Access Compliance Report

Public Rights-of-Way

(Curb Ramps)

Intersection ID: 3628	Main Street: DICKSON_LN	Cross Street: MAYCROFT_DR	Location:	N
ADA ID: 3822D52E7606	Ramp Type: Perp	Initial Pass/Fail: Fail	Overall Compliance: No	Severity Score: 1.25
Codes/Mitigation Info/Possible Solution		Field Measurements/Component Compliance

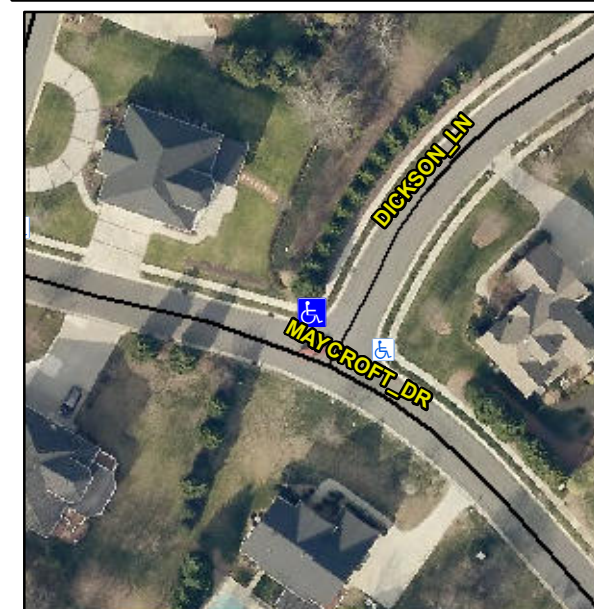
Not Found, R304.5.3

Compliance	Description	Data	Compliance	Description	Data
N/A	Ramp Length (in)	50.0	Yes	Ramp Slope (%)	5.1
Yes	Ramp Width (in)	102.0	No	Ramp XSlope (%)	2.6
N/A	Flare Type LT	N/A	N/A	Flare Type RT	N/A
N/A	Flare Slope LT (%)	N/A	N/A	Flare Slope RT (%)	N/A
N/A	Flare Traversable LT?	N/A	N/A	Flare Traversable RT?	N/A
N/A	Landing Length (in)	N/A	N/A	DWS Provided?	N/A
N/A	Landing Width (in)	N/A	N/A	DWS Contrast?	N/A
N/A	Landing Slope (%)	N/A	N/A	DWS Length (in)	N/A
N/A	Landing X Slope (%)	N/A	N/A	DWS Full Width?	N/A
N/A	Landing Curb? (Y/N)	N/A	N/A	DWS Offset (in)	N/A
N/A	Shared Landing?	N/A			
N/A	Gutter Ponding?	N/A	N/A	Gutter Slope (%)	N/A
N/A	Gutter Lip Ht (in)	1.0	N/A	Gutter X Slope (%)	N/A
N/A	Painted X Walk1?	No	N/A	Painted X Walk2?	N/A
	X Walk 1 Direction	To SE		X Walk 2 Direction	N/A
N/A	X Walk 1 Width (in)	N/A	N/A	X Walk 2 Width (in)	N/A
	X Walk 1 Slope (%)	8.0		X Walk 2 Slope (%)	N/A
	X Walk 1 X Slope (%)	0.2		X Walk 2 X Slope (%)	N/A

Remove & Replace Entire Ramp.
